| This ASB revises ASB-912-061 dated 26 May 2012

ALERT SERVICE BULLETIN

Replacement of the pressure side fuel hose at fuel pump part no. 893114 for ROTAX® Engine Type 912 (Series)

ATA System: 73-00-00 Fuel system

Fig. 1
Fuel pump

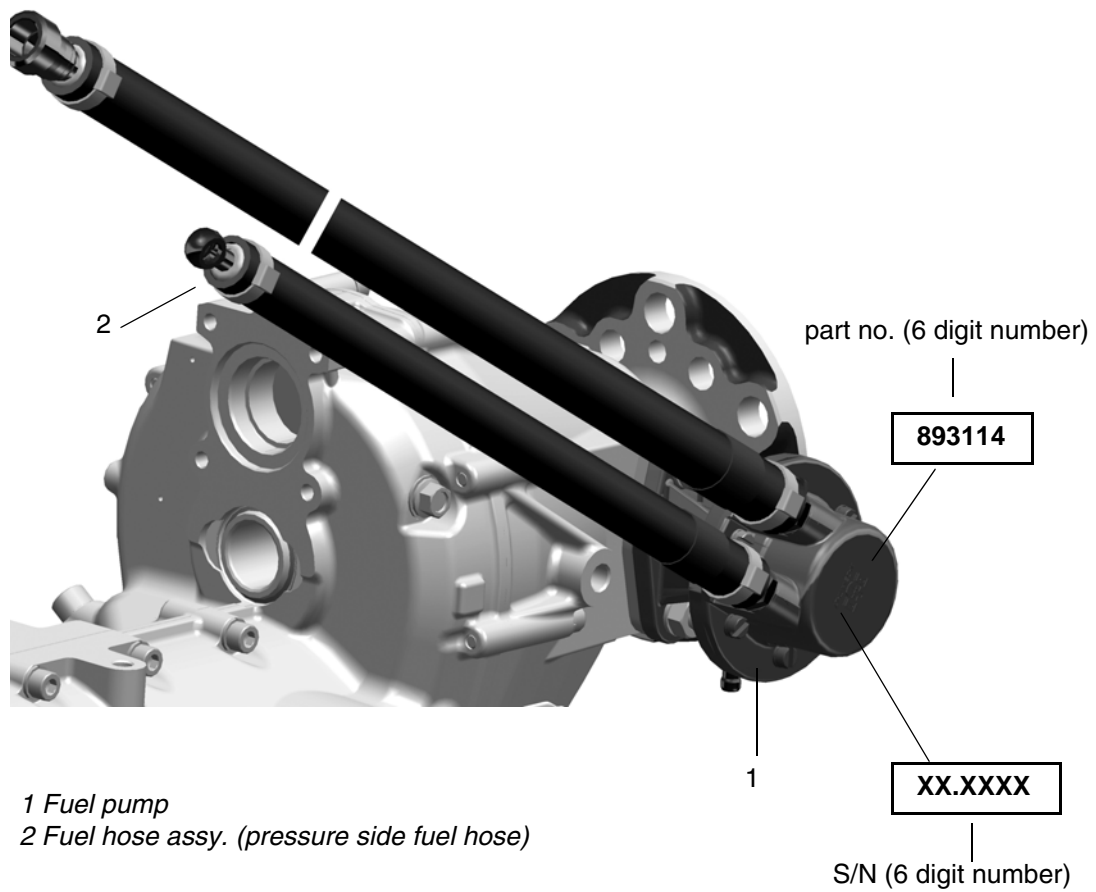
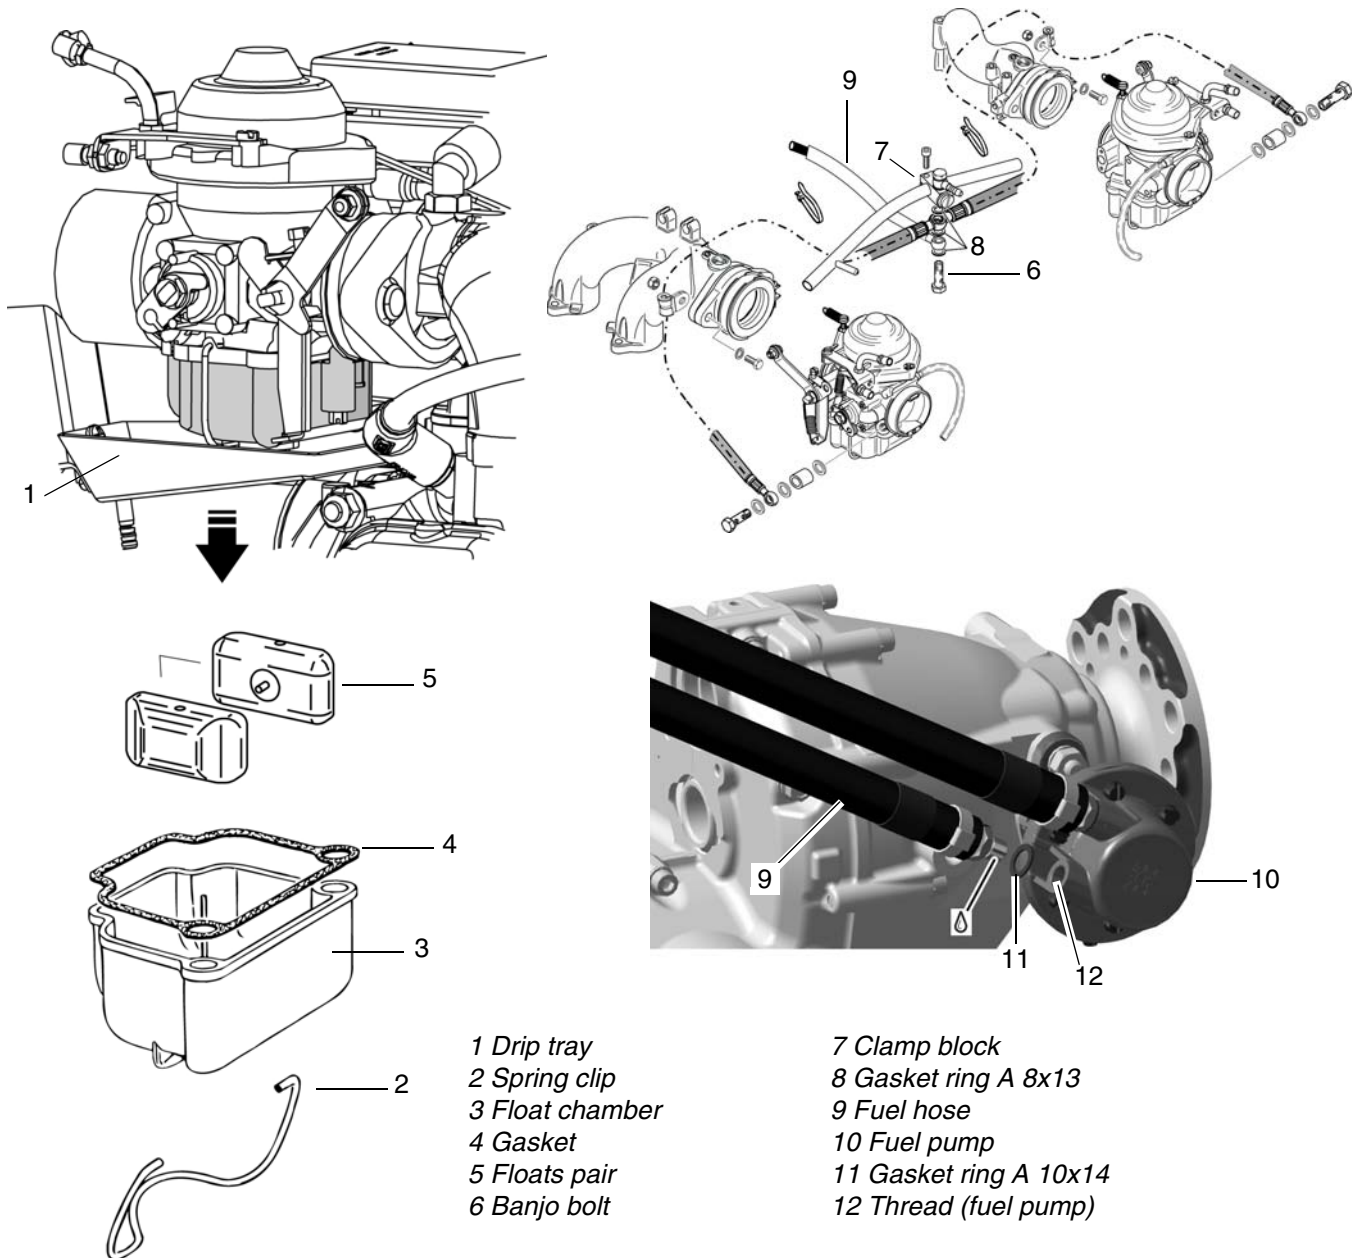
if they are equipped with the genuine ROTAX® fuel pump part no. 893114.
See [Fig. 1](#)

In addition, are also affected, all fuel pumps part no. 893114 with S/N 12.0261/12.0262/11.3117 up to 11.3122 inclusive/11.3124 up to 11.3127 inclusive/ 11.3131 up to 11.3135 inclusive/11.3140/11.3142/11.3145/11.3156/11.3158 up to 11.3160 inclusive/11.3174/11.3175/11.3186 up to 11.3225 inclusive/11.3252/11.3267 up to 11.3270 inclusive/ 11.3297 up to 11.3300 inclusive/11.3302 up to 11.3305 inclusive/11.4036 up to 11.4155 inclusive/ 11.4157/11.4159/11.4164/11.4186 up to 11.4195 inclusive/11.4206 up to 11.4235 inclusive/ 11.4244 up to 11.4246 inclusive/11.4256 up to 11.4265 inclusive/11.4284/11.4306 up to 11.4316 inclusive/11.4318/11.4319/11.4321/11.4322/11.4327/11.4331 up to 11.4335 inclusive/11.4516/ 11.4545/11.4549 up to 11.4552 inclusive/11.4554/11.4555/11.4566 up to 11.4585 inclusive, delivered as spare parts or installed at engine maintenance/general overhaul.
